Aircraft Design Certification GmbH Reichensteinstr.48 69151 Neckargemünd		Bristell B23	Doc-Nr: ADxC-73-SB-020 Issue: A Date: 09.01.2023 ChangeNr.: ADxC-73-DC-061
Service Bulletin

Bristell B23 Inspection and change of ballast attached to engine
--

ATA 72 ENGINE – ballast attached at engine

Figure 1 Installation drawing (showing Ballast 71B200201 Issue E. The reworked Issue D has straps instead of patches

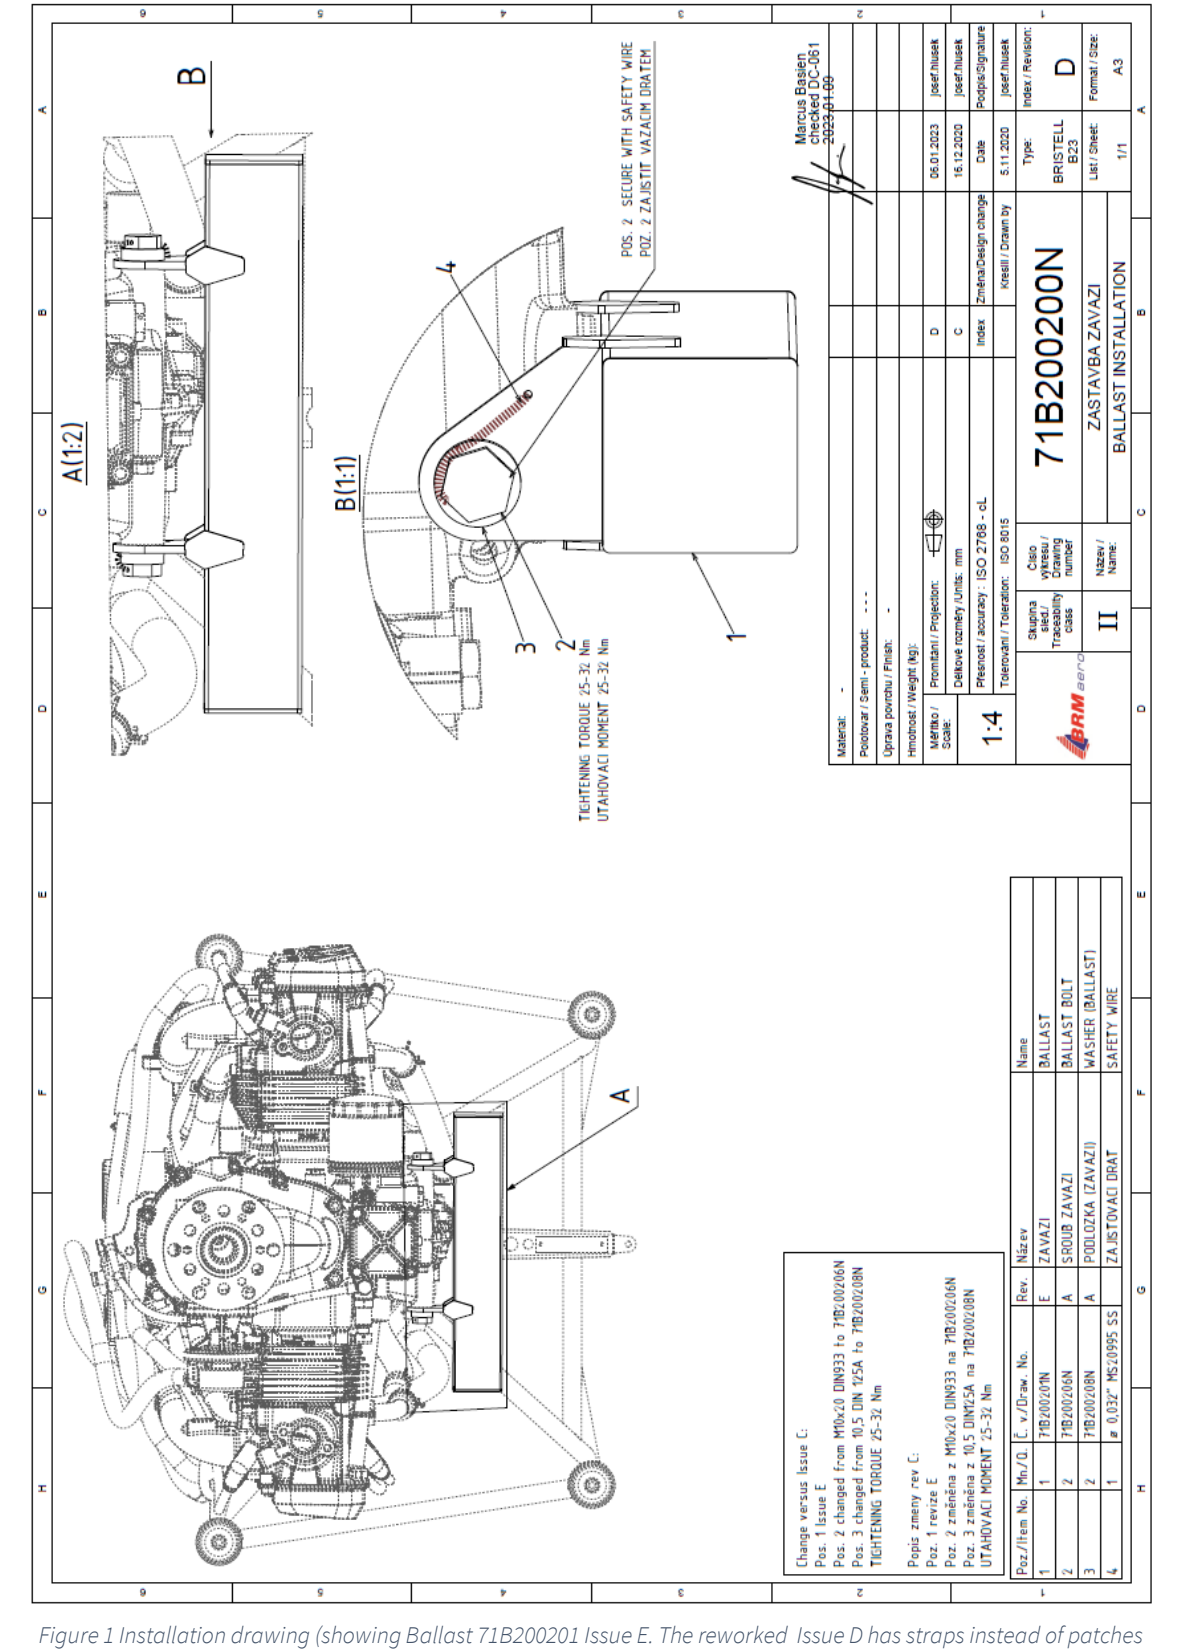
- Remove engine cowling
- Remove safety wire at ballast attachment bolts
- Install factory reworked ballast PN 71B200201N issue D (*OR new 71B200201N issue E Ballast*) using bolts PN 71B200206N issue and 71B200208N issue A washer (2ea) according installation drawing 71B200200N issue D; Torque attachment bolts to 26-32 Nm
- Perform engine run up according AFM, perform minimum 5 rapid RPM changes idle to max RPM. Shut down aircraft according AFM.
- Recheck torque of bolts PN 71B200206N issue A after cool down.
- Reapply safety wire.
- Reinstall cowling.

Figure 2 Cracks found on ballast lug

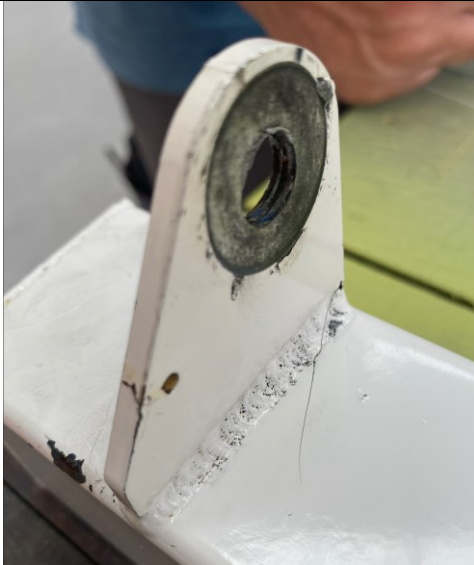
- Visually inspect ballast for cracks: no cracks allowed, see Figure 2
- Visual inspect ballast attachment lug holes – no elongation or wear allowed. Nominal diameter of hole 10.0mm tolerance +0.015/-0.0

- Remove engine cowling
- Visually inspect ballast for cracks: no cracks allowed, see Figure 2
- IF cracks are found sent to BRM for repair/upgrade (immediate terminating action).
- IF ballast is free of cracks: Reinstall cowling.

- If cracks or hole wear is found sent to BRM for repair/upgrade (immediate terminating action).
- If ballast is free of cracks or hole wear reinstall ballast (mind correct orientation) using 71B200206N issue A Ballast bolt (2ea) and 71B200208N issue A washer bolt (2ea)

Figure 4 Grey dust on ballast indicating wear on bolt/thread/attachment)

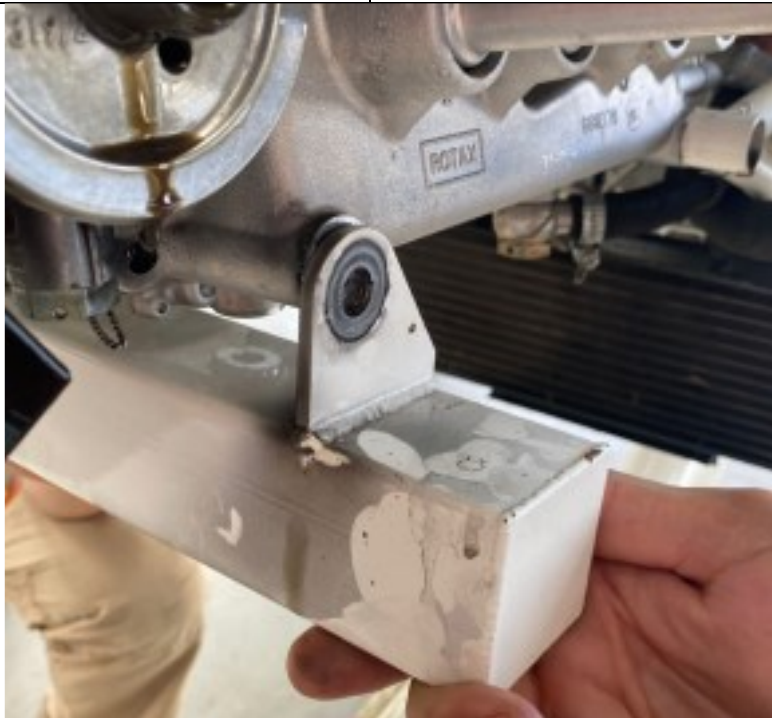
- Remove engine cowling
- Visually inspect the surface of the ballast for cracks occurrence in the area of attachment to the engine and/or signs of a loose connection indicated by the appearance of grey-black dust, see Figure 4 in Appendix.

- Remove safety wire at ballast attachment bolts
- Remove bolts and ballast
- Discard bolts
- If grey dust was found: Visual inspect engine threaded hole: no thread damage is allowed. In case of thread damage contact BRM, installation of helicoil might be needed.
